ITEM E9 – STRAWBERRY ACRES SUBDIVISION 2022 REPLAT

KPB File # 2022-025

Strawberry Acres 2022 Replat

STAFF REPORT

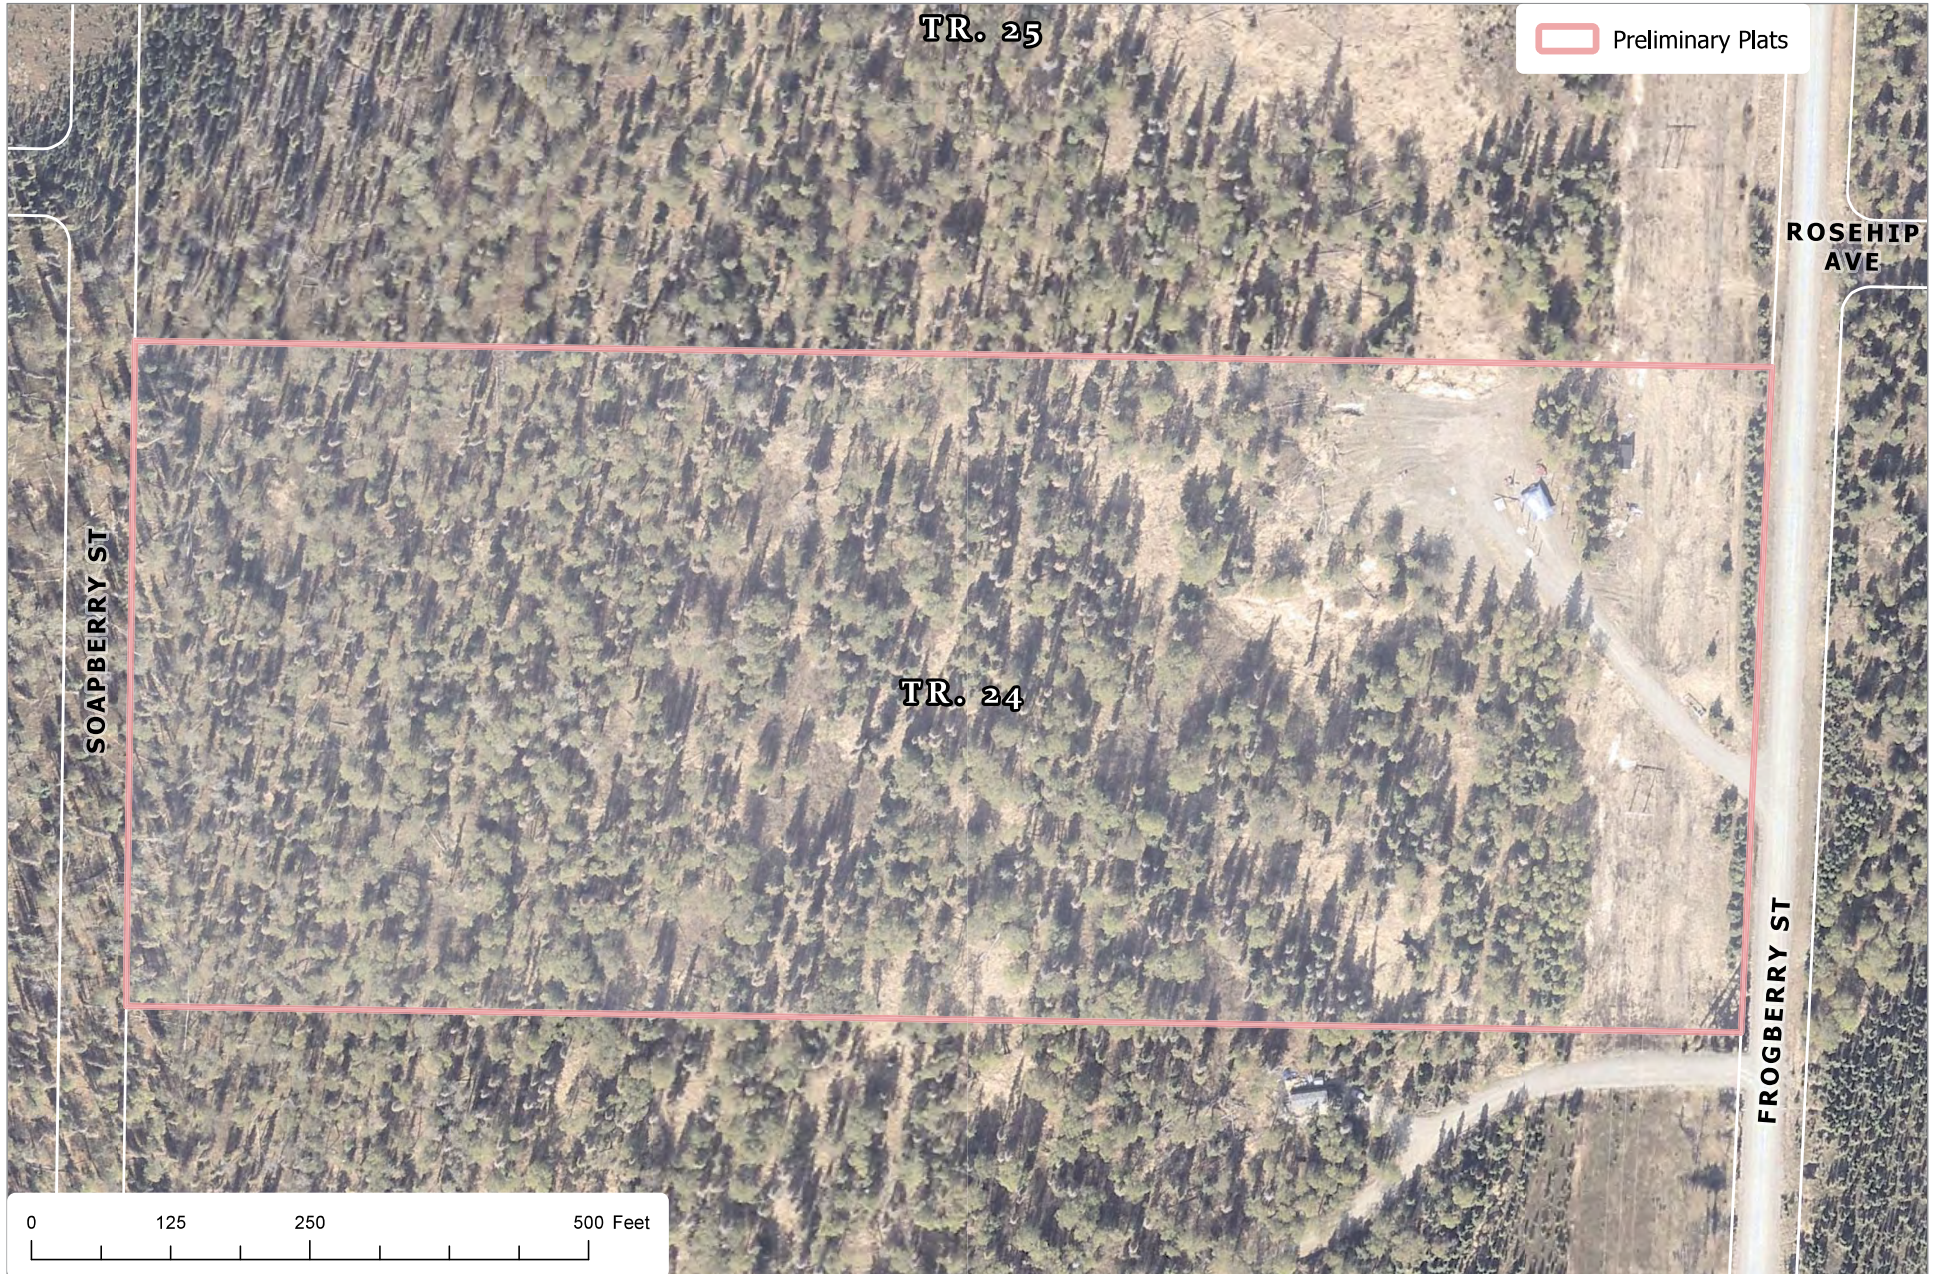
A driveway is present from Frogberry Street. Based on the design it appears the driveway may cross Tract 24B to provide access to Tract 24A. ***Staff recommends the location of the driveway be determined and if crossing both lots, a driveway easement may need to be recorded.***

The subdivision contains steep slopes that run through the middle of the proposed lots. The preliminary plat contains contour information. **Staff recommends** the contour lines can be removed but the toe and top of the slope remain as shown on the preliminary plat.

Utility Easements The parent plat designated the 20 foot building setback as a utility easement with clearing limited to the front 10 feet. The existing plat note states the front 10 feet adjacent to the right of ways and increasing to 20 feet within 5 feet of the side lots lines will be a utility easement. **Staff recommends the plat note for the utility easement be updated to reflect what was previously granted and the building setback label either include “and utility easement” or refer to the plat note number.**

The parent plat did indicate an electric transmission line and natural gas easement ran along Frogberry Street. **Staff recommends the easement along the eastern boundary of this subdivision must be depicted and labeled.**

An additional easement is noted on the Certificate to Plat as being granted in Book 209 Page 369. The certificate to plat indicates no definite location is disclosed and it is noted in plat note 3. However, the document contains descriptions and states there is a 200 foot easement along the eastern boundary of this subdivision. This easement may coincide with the one depicted on the parent plat. **Staff recommends the plat note be revised to remove “No definite location disclosed”, update the depictions and plat notes to include the existing easements and if needed provide labels to plat notes to explain the easements and how they were granted.**

- Staff recommendation:** Carry over "Subdivision" within the name. Simplify the description of the location by using "NE1/4 Section 32 and the NW1/4 Section 33".

- Staff recommendation:** Note the Kenai National Wildlife Boundary. Continue the City Limits boundary.
- G. The status of adjacent lands within 100 feet of the proposed subdivision boundary or the land status across from any dedicated rights-of-way that adjoin the propose subdivision boundary, including names of subdivisions, lot lines, block numbers, lot numbers, rights-of-way; or an indication that the adjacent land is not subdivided;

- Staff recommendation:** Provide a tract label and subdivision recording number for the tract west of Soapberry Street. Provide a tract label and subdivision recording number for the tract east of Frogberry Street. Depending on the surrounding area shown to include those tracts, Rosehip Avenue and Bearberry Avenue may need to be shown and include right of way widths.

- Plat note 3 state no definite location, as does the certificate to plat, however the easement does contain exhibits that show the locations. Update the plat note to remove “no definite location” and depict the easement with a reference to the plat note.
- Plat note 4 should carry over the easement as granted by the parent plat. “The 20 foot building setback shall also serve as a utility easement with clearing restricted to front 10 feet of the setback as granted by Plat KN 85-185.”
